From: Kristen Bryant [<mailto:kristenbry@gmail.com>]
Sent: Tuesday, July 01, 2014 5:09 PM
To: Brenda Martinez; info
Subject: SEPA Comments related to Plat 2C per city notice of June 16.

WETLANDS AND STREAMS

A. INSUFFICIENT EVIDENCE TO JUSTIFY RATING CATEGORY FOR SEGMENT OF WETLAND E1

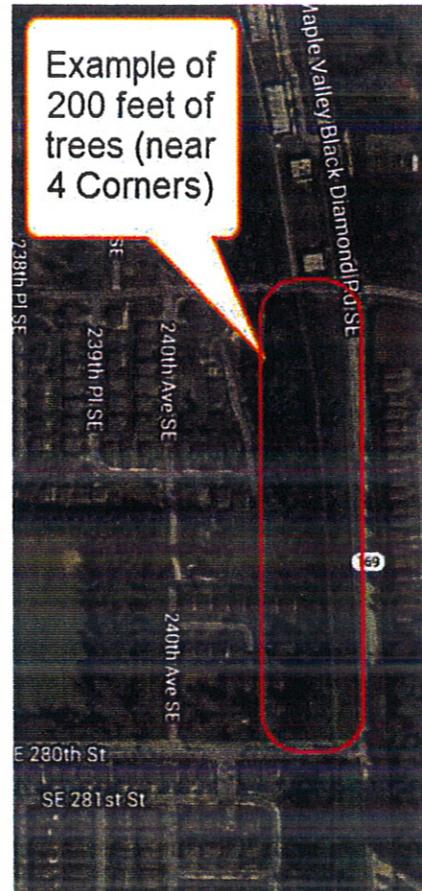
The documents provided by the city do not show that the necessary scientific work was done to justify the separation of Wetland E1 into two separate rating categories. By allowing this separation, the portion of Wetland E1 in Plat 2C had its buffer width set at 110 feet instead of the required 225 feet if this single wetland were not separated into 2 units.

Wetland E1 was previously scored a Category 1 wetland with a 225-foot buffer. The change to downgrade a segment of it to Category 2 did not receive enough review.

1. Wetland E1 buffer was reduced from 225 to 110 feet.
2. A walking trail planned for inside the 110-foot buffer is located in the outer 50% of that smaller buffer, but if the buffer were a 225' buffer, the trail would clearly be within the inner half. If the wetland is Category 1, the trail would be allowed only in the outer 25% of the 225' buffer, so it would be over 170' away from the wetland. Now, with the trail in the 110' buffer, the trail is only 60' feet away from the wetland in some places.

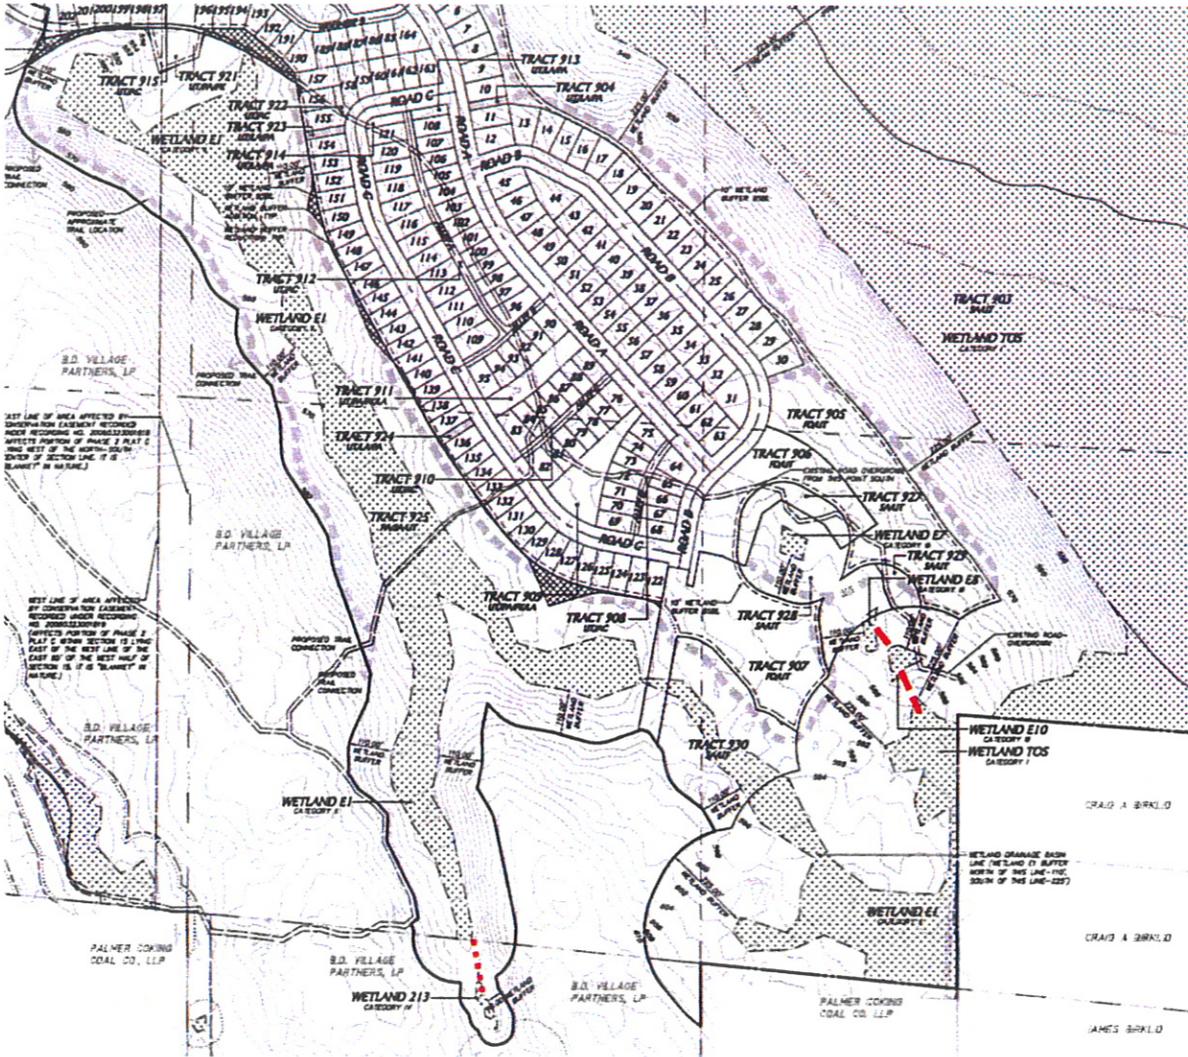
This map taken from the Plat document has red lines between certain small wetlands that may in fact be connected to the larger wetlands near them.

The dashed red lines show that Wetlands marked separately as Wetland E8, Wetland E10, and Wetland E213 may in fact be connected during the wet season.

If they are connected, they increase the size of their larger adjacent wetlands and take on their buffer widths. In addition, the wrong delineations could lead to a violation of federal laws.

This is a potential increase to 225' feet for wetlands E8 and E10. This would likely prevent future development of Tract 907 and part of Tract 905. The city should send a reviewer out to verify these wetlands.

Figure 1. Segment of city's Best Available Science Critical Areas Map, with orange outline showing possible stream:

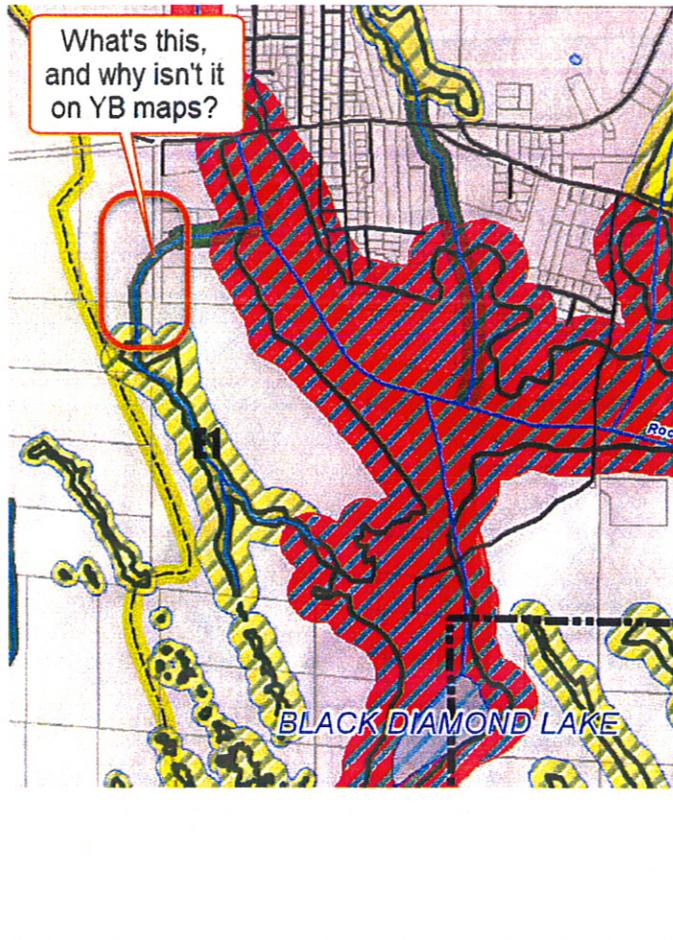
Other maps show a stream near the north edge of wetland buffer E1 extending to Rock Creek. This stream is not addressed in the plat drawings.
